PIC16(L)F1782/1783 Family Silicon Errata and Data Sheet Clarification

The PIC16(L)F1782/1783 family devices that you have received conform functionally to the current Device Data Sheet (DS41579D), except for the anomalies described in this document.

FIGURE 1: ADC 12-BIT MODE, SINGLE-ENDED INL, $V_{DD} = 3.0V$, $T_{AD} = 4 \mu s$, $25^{\circ}C$, TYPICAL MEASURED VALUES

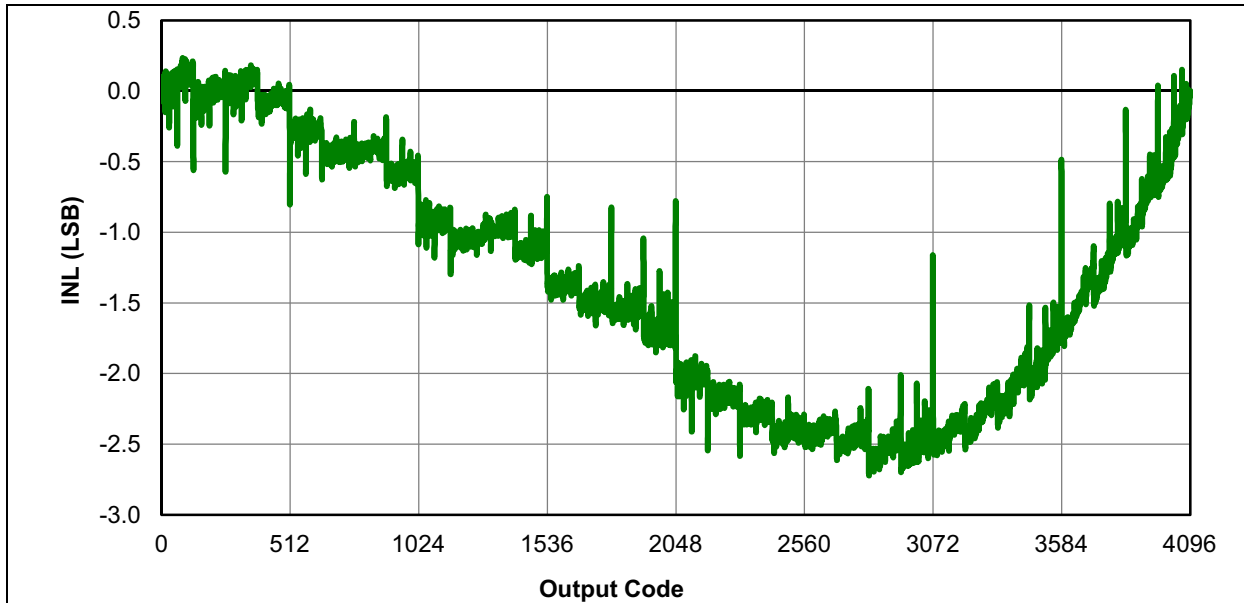
The ADC linearity is ± 4 LSB for the 12-bit mode. Below are typical INL graphs in 12-bit mode (See [Figure 1](#) and [Figure 2](#)).

None.

FIGURE 3: OP AMP TYPICAL OFFSET VOLTAGE AT 25°C, HIGH GBWP MODE (OPAxSP = 1), VDD = 3.6V, 0V ≤ CMV ≤ 5.5V

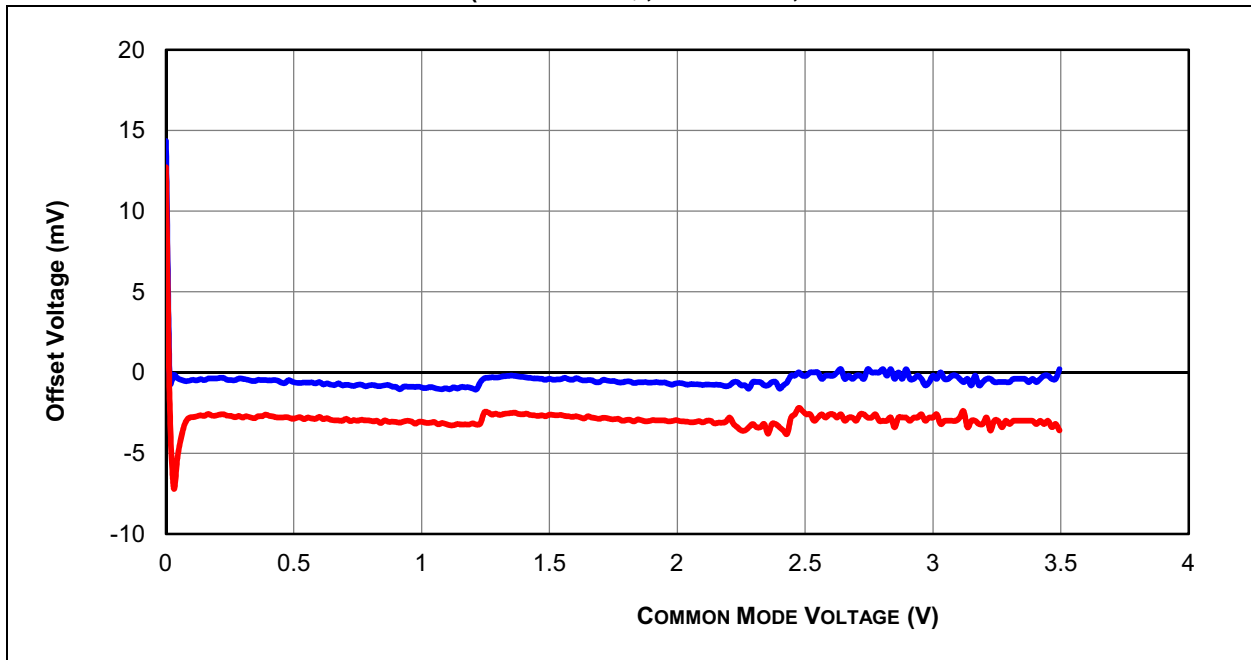
The op amp offset at Common mode input voltages below 200 mV increases with respect to temperature. Below are typical graphs showing the increase in offset (See [Figure 3](#), [Figure 4](#) and [Figure 5](#)).

None.

FIGURE 6: COMPARATOR INPUT OFFSET, TYPICAL MEASURED VALUES, NORMAL SPEED MODE (CxSP = 1), $V_{DD} = 5.5V$, PIC16F1782/1783 ONLY

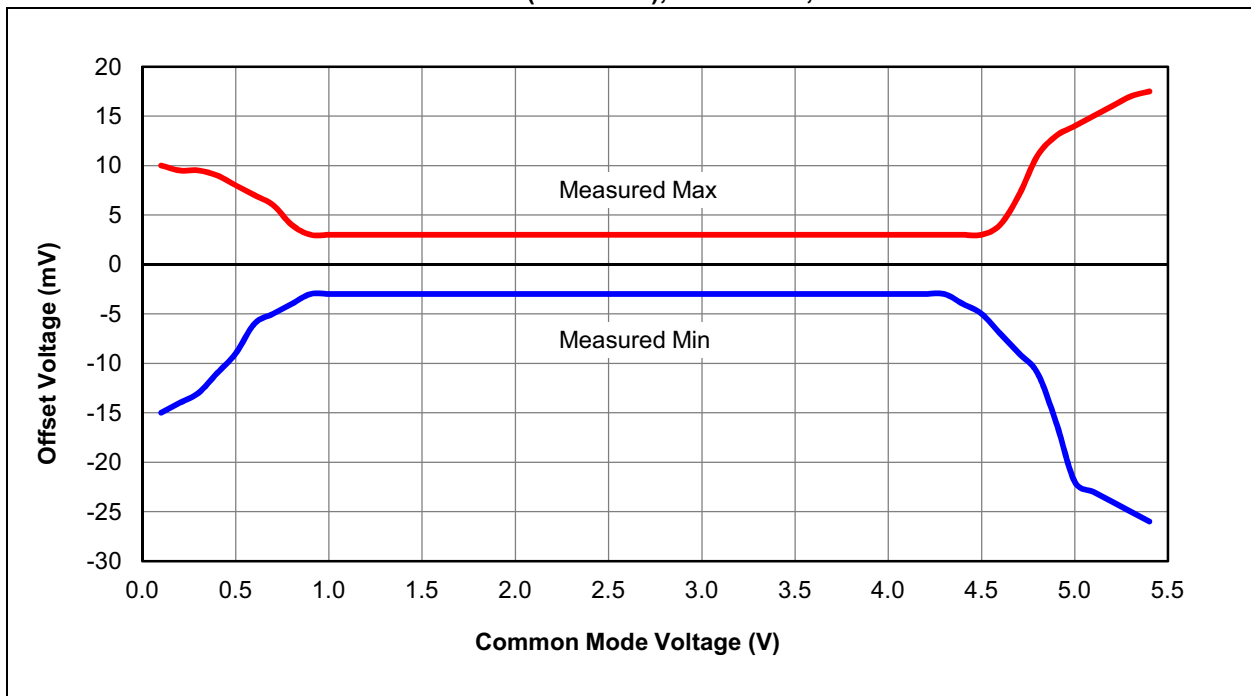
CMRR performance for the range of $V_{SS} + 1V$ to $V_{DD} - 1V$ is better than specified in the data sheet.

See [Figure 6](#) and [Figure 7](#).
